5TH AND VIRGINIA

Proposed MUP #3018037

# SECTION 02. RESPONSE TO EDG

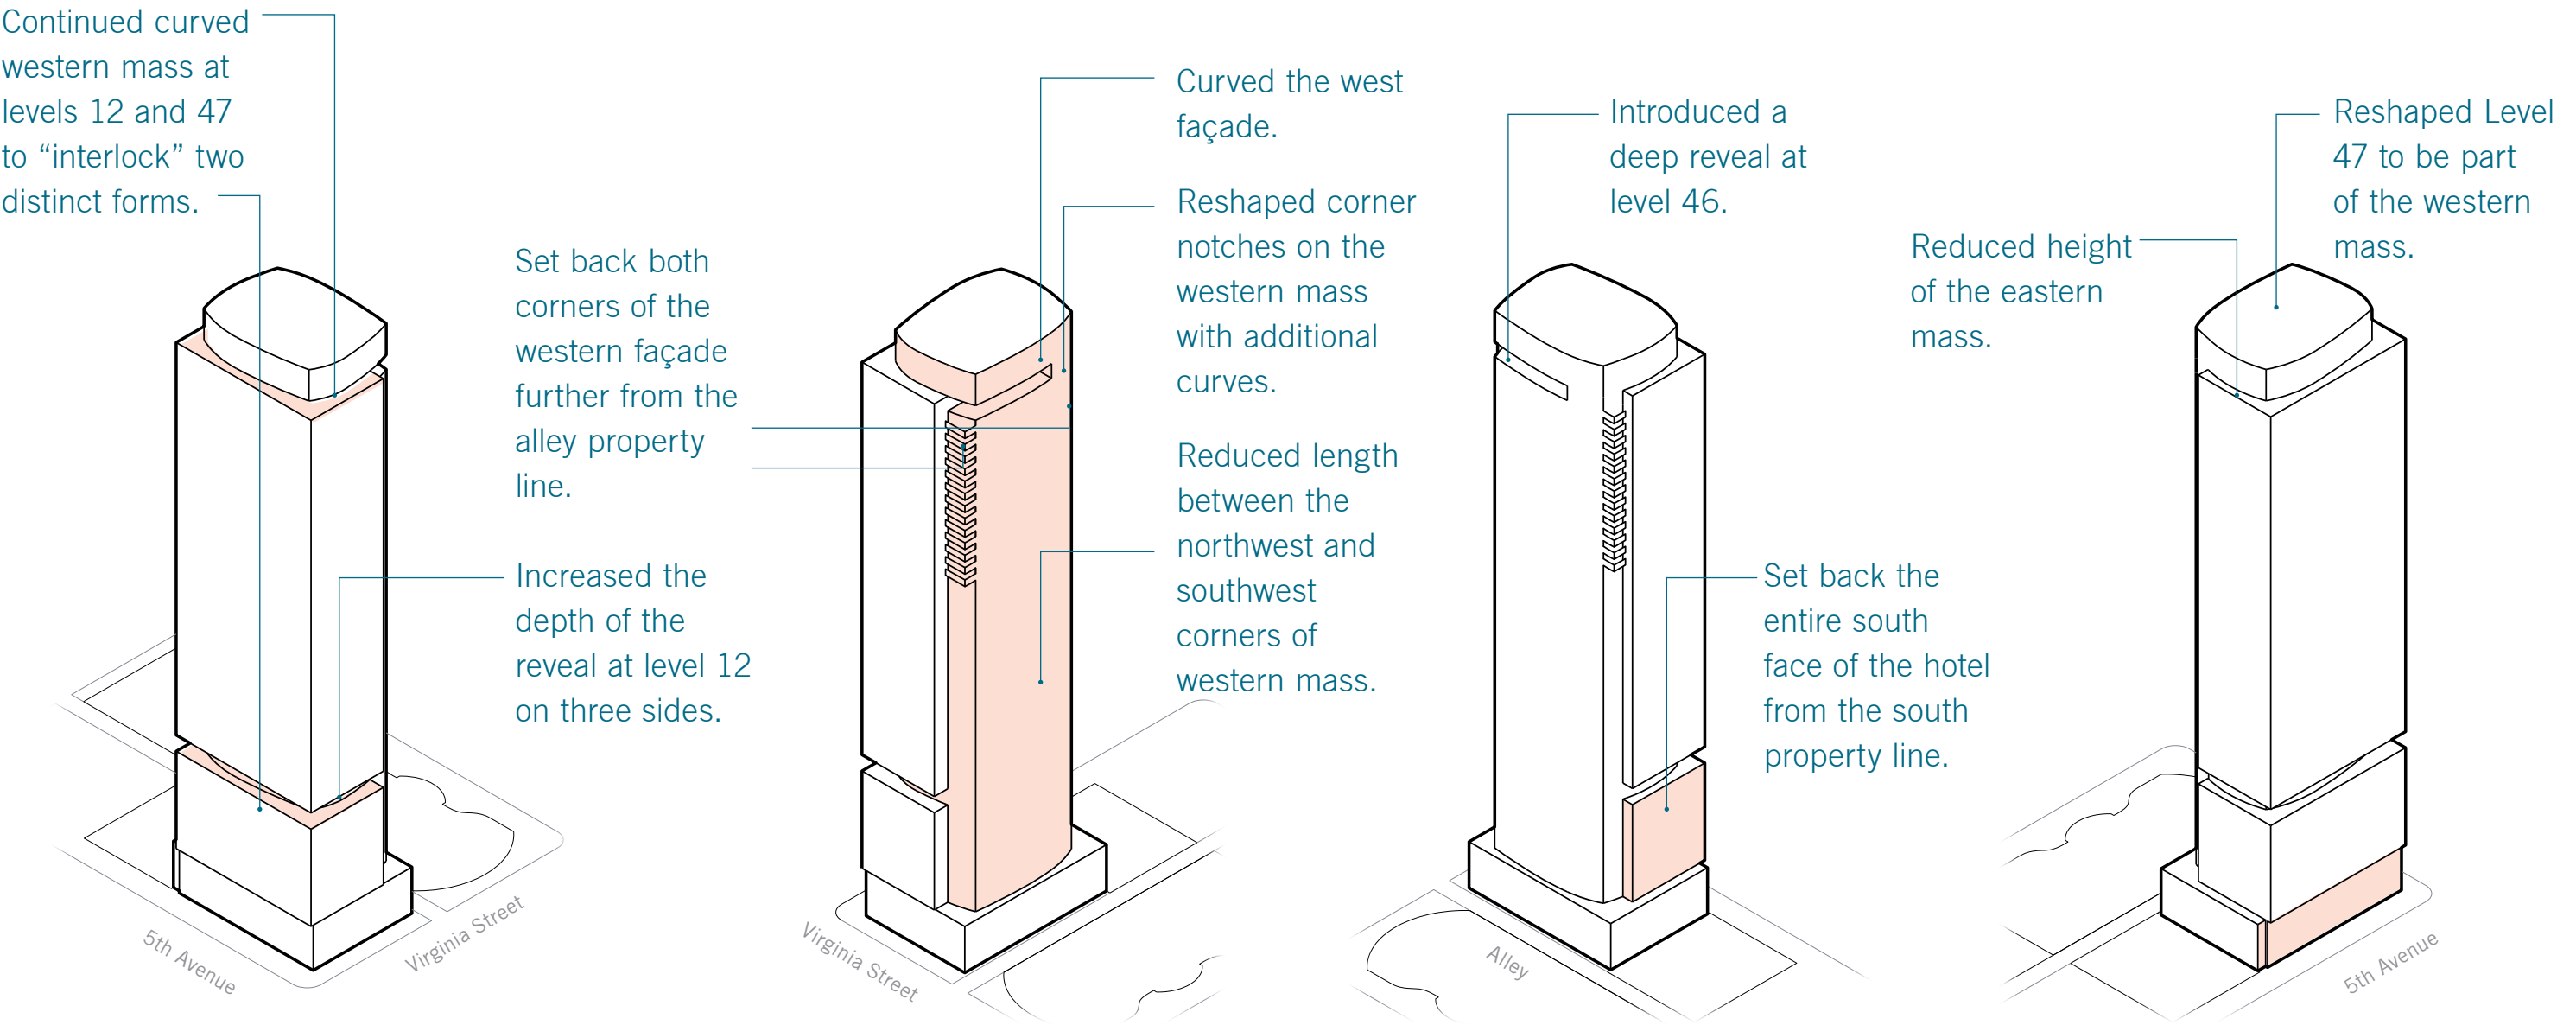
The Board supported the reshaped south and north tower plans from floor 4 up, as they resulted in a more slender and vertical proportion, as best depicted on pg 30. The Board noted this basically uniform massing extrusion is completely contingent upon the legible and successful resolution of the façade and material distinctions described under 5d and 7a below. (A1, B1, B3)

The tower proportion and massing have been modified to reflect EDG guidance as follows.

These combined revisions to massing and building form preserve and enhance the slender proportion and other design concepts supported by the board. The modifications in response to Board guidance are to enhance privacy, increase access to light and air, increase openness to views, and to strengthen the distinction and legibility of east and west mass and the buildings public spaces.

5(C) MECHANICAL PENTHOUSE /

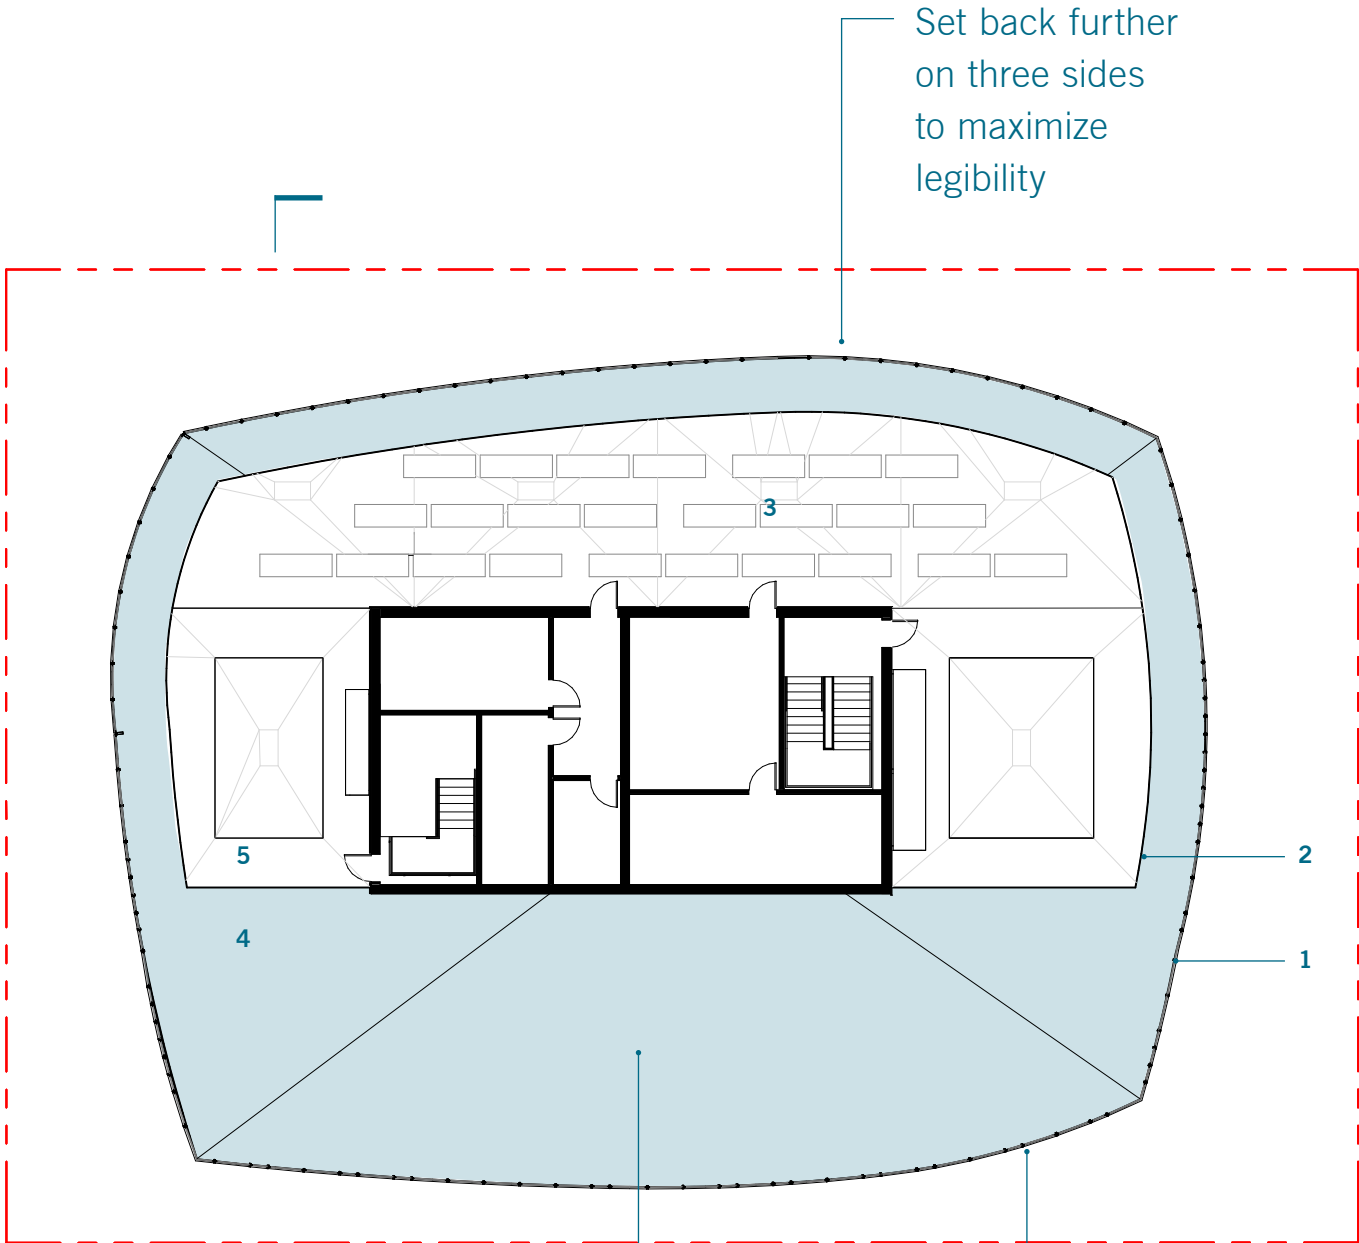
The Board strongly supported the stepped form at level 47, as it sets off the east portion as the proposed ‘lantern’ at a proper proportion (eg, the step can occur lower but not higher). The 2 layer glass enclosure of mechanical equipment is a critical compositional element on the skyline, as shown on pg 53, and should not become a generic louvered screen. See 7b for the Board recommended treatment for both the floor 12 reveal and the building top ‘lantern’. (A2.1.c; A2.2)  
*For response, see pages 26, 27*

The mechanical penthouse treatment and "glass lantern" rooftop bar have been enhanced in response to Board guidance by significant measures, as follows:

5(D) WEST FACADE MASSING /

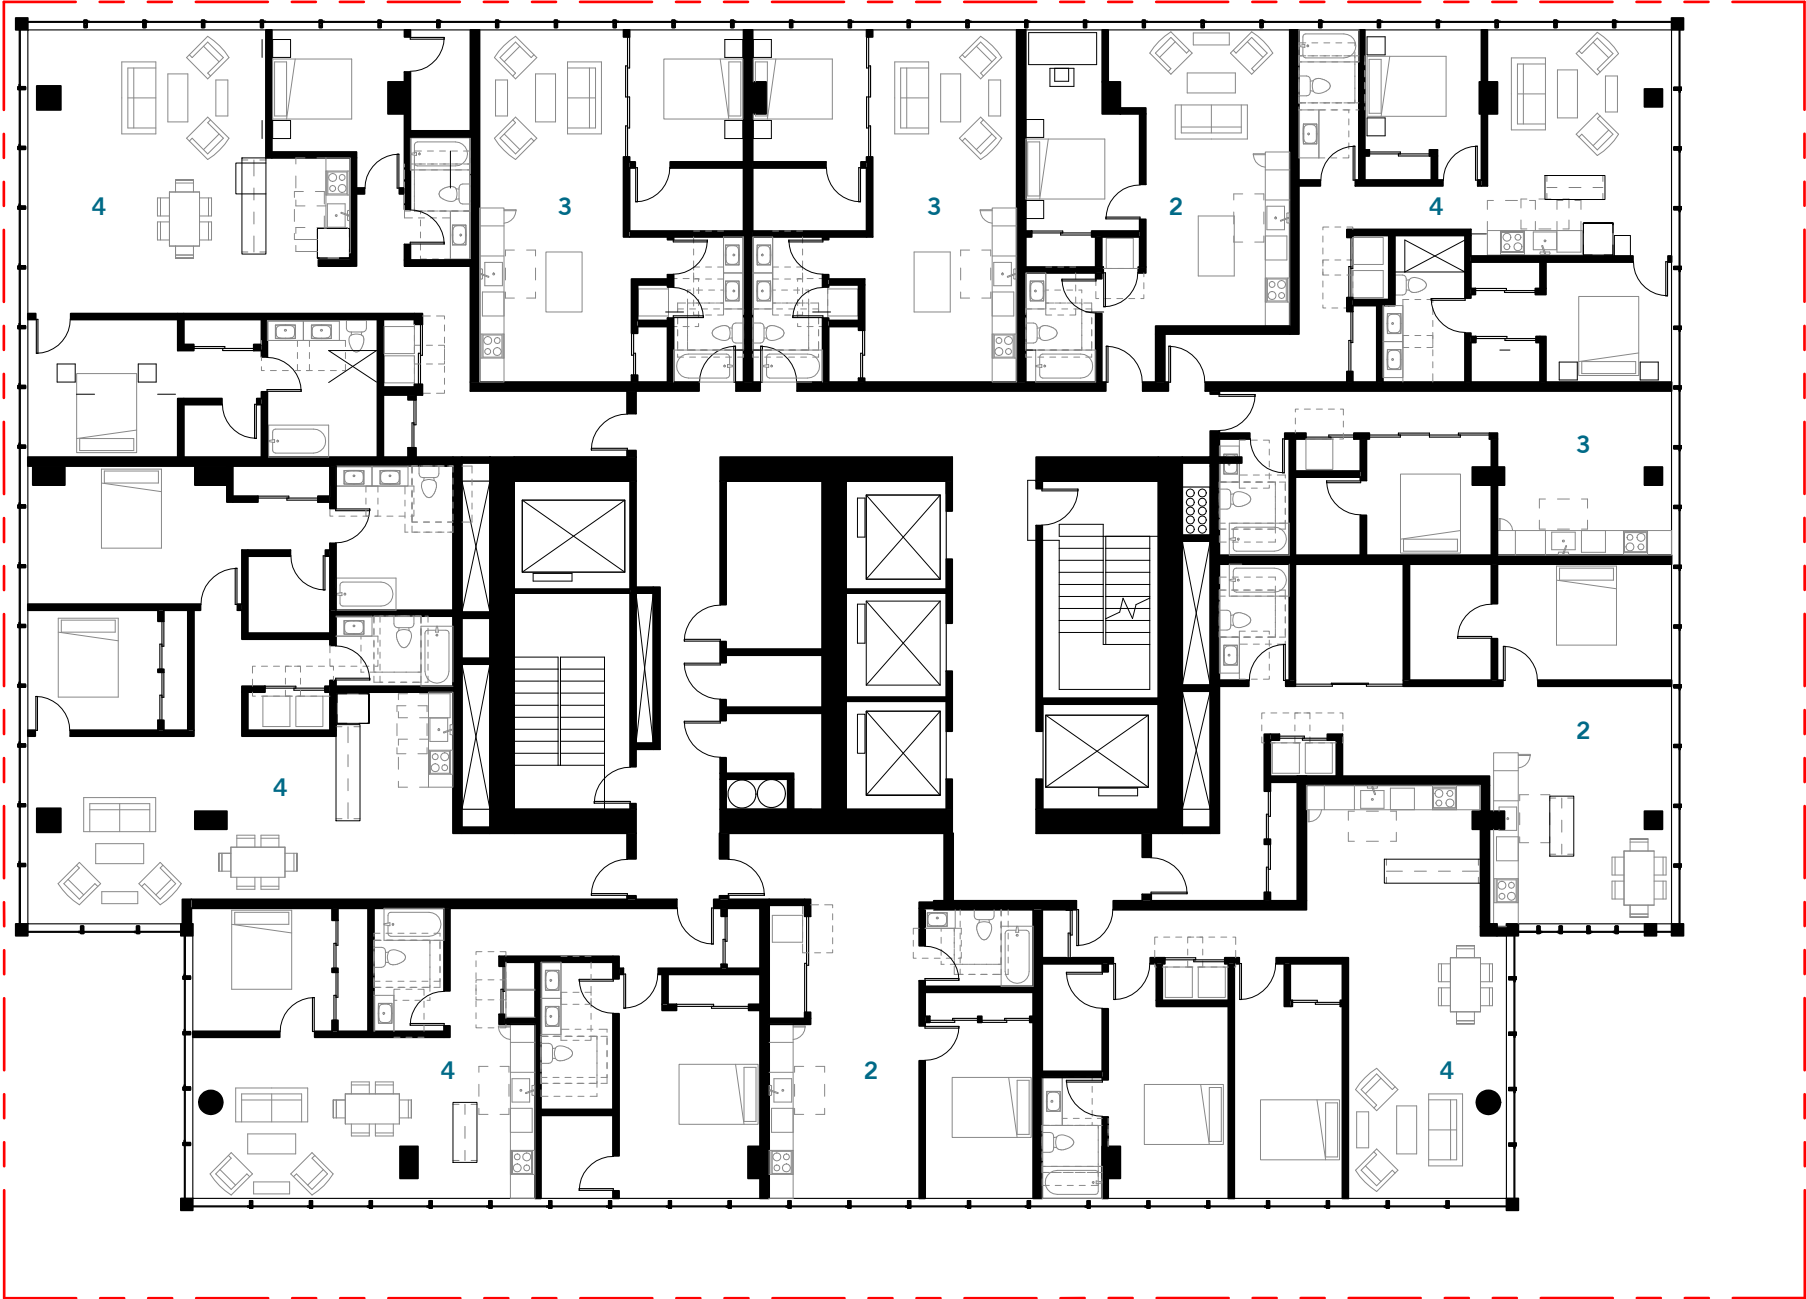
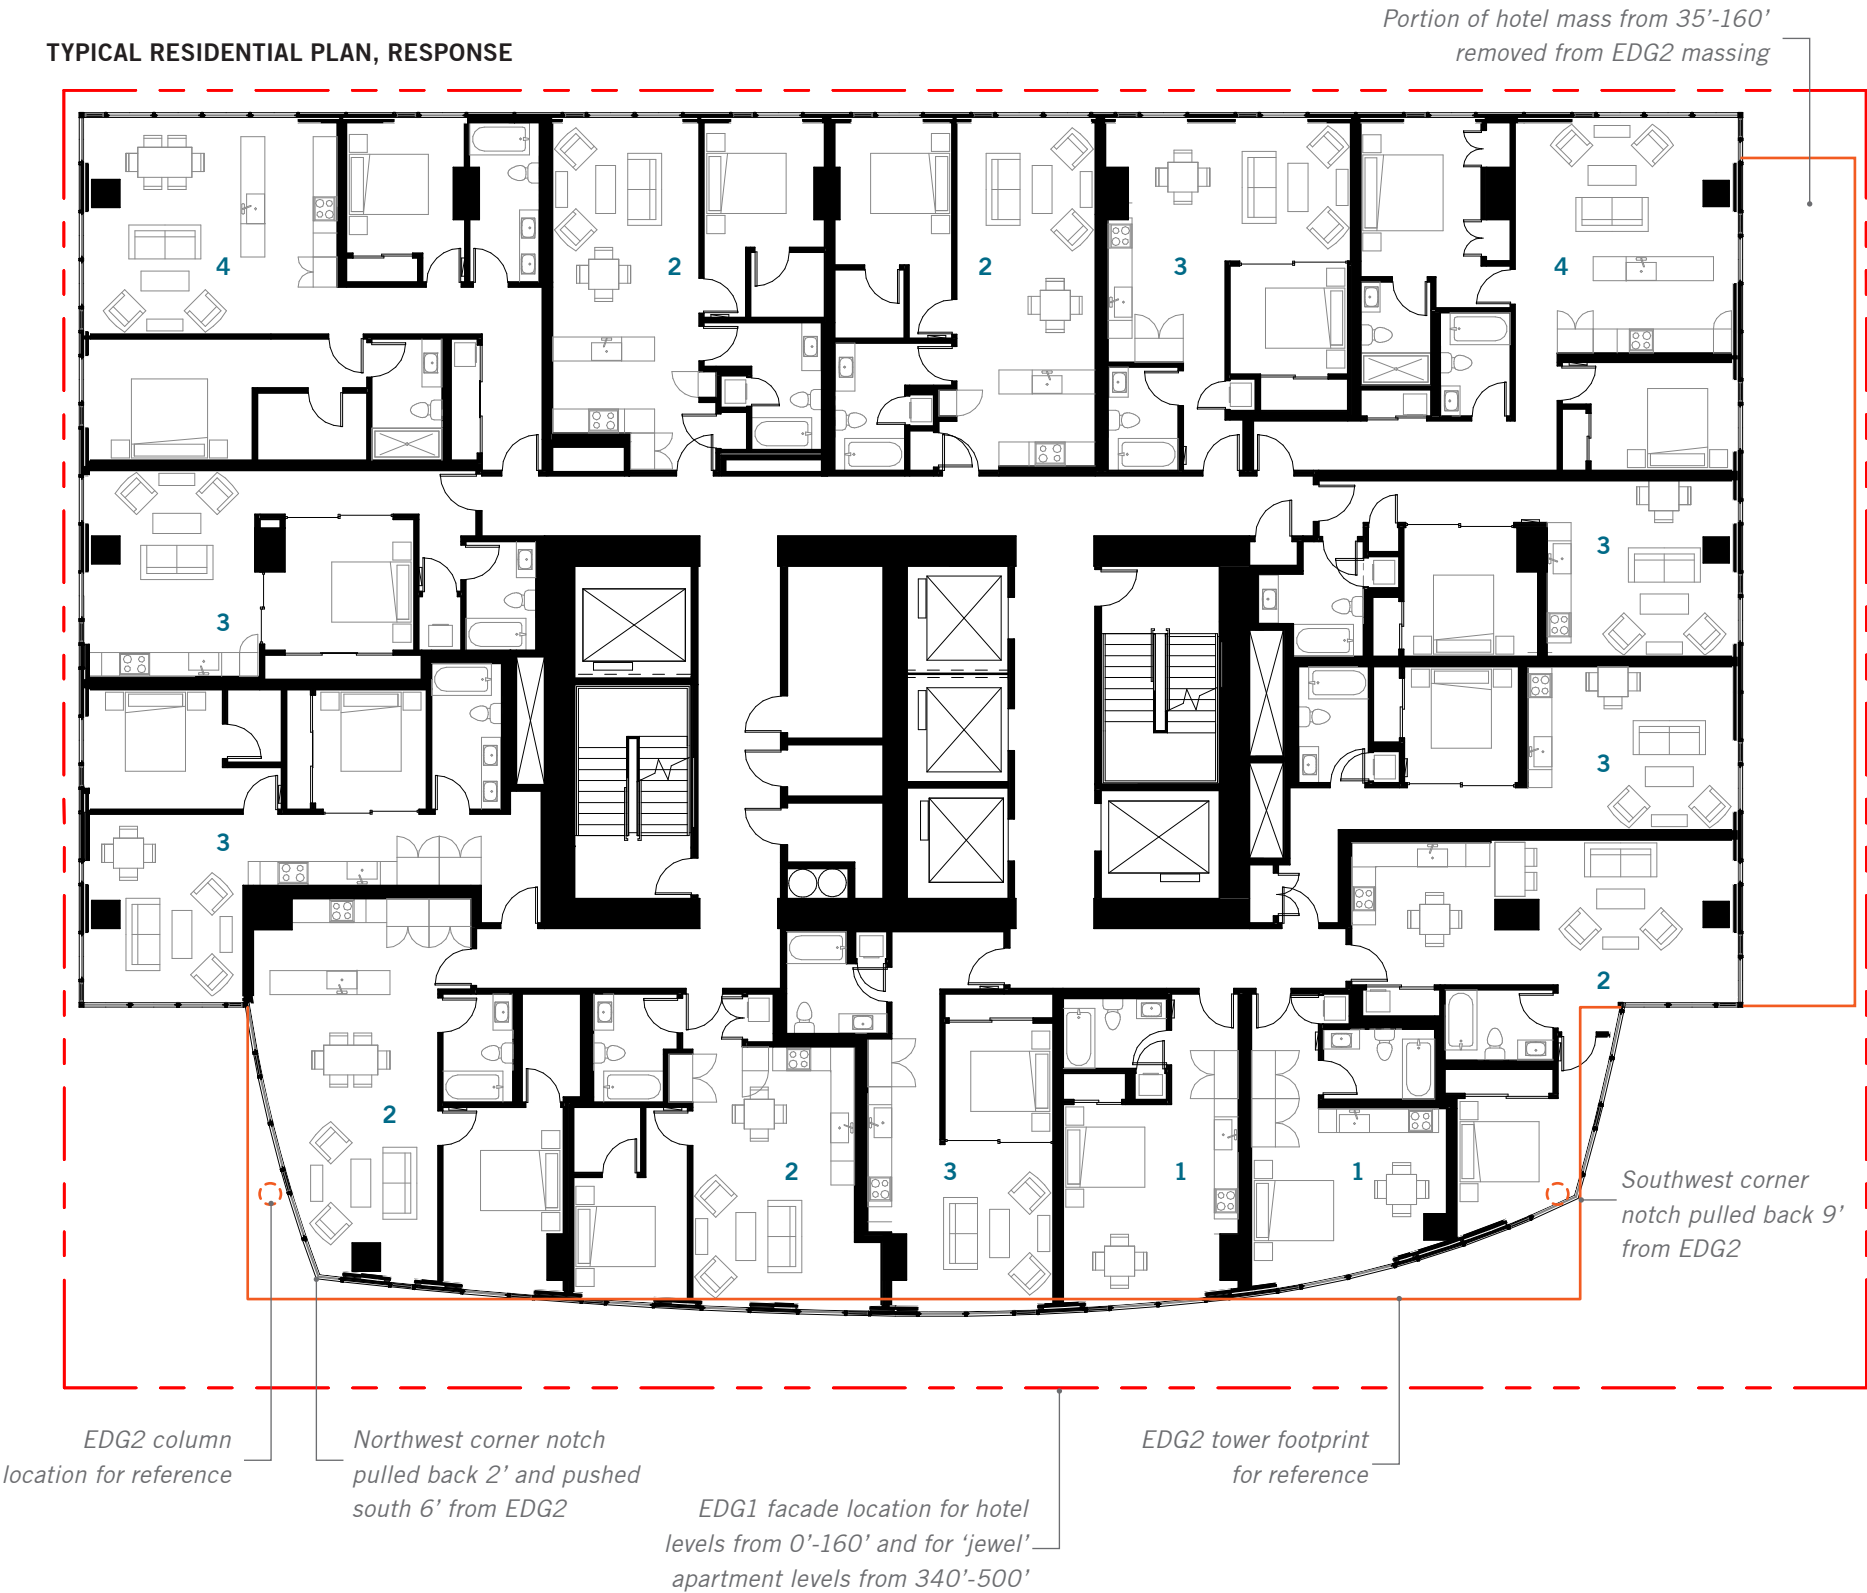
The Board continued to focus on the west façade and ‘saddlebag’ element, for both architectural and adjacency concerns. The Board agreed that the full height of this projecting element, whatever its final shape, should be expressed with a different and more solid character to clearly distinguish it from the east tower extrusion it abuts (also see comments under 7a).

Since the Board recommends this element is fundamentally a different mass, its shape does not need to match the 90 degree corners of the east extrusion. [Staff NOTE: the mid tower floor plans 13-32 shown on page 47 are larger areas than the corresponding plans shown on pg 68 at EDG#1, when the Board also recommended shaping of this west elevation: EDG#1, item 1d] (B3, C6.III)

The western façade massing has been have been modified to reflect EDG guidance as follows:

8. Reduced the overall vision glass area of the western façade.

9. Introduced balconies at the north and south above Escala.

10. Resolved the ‘interlock’ between the east and west massing with deeper setbacks.
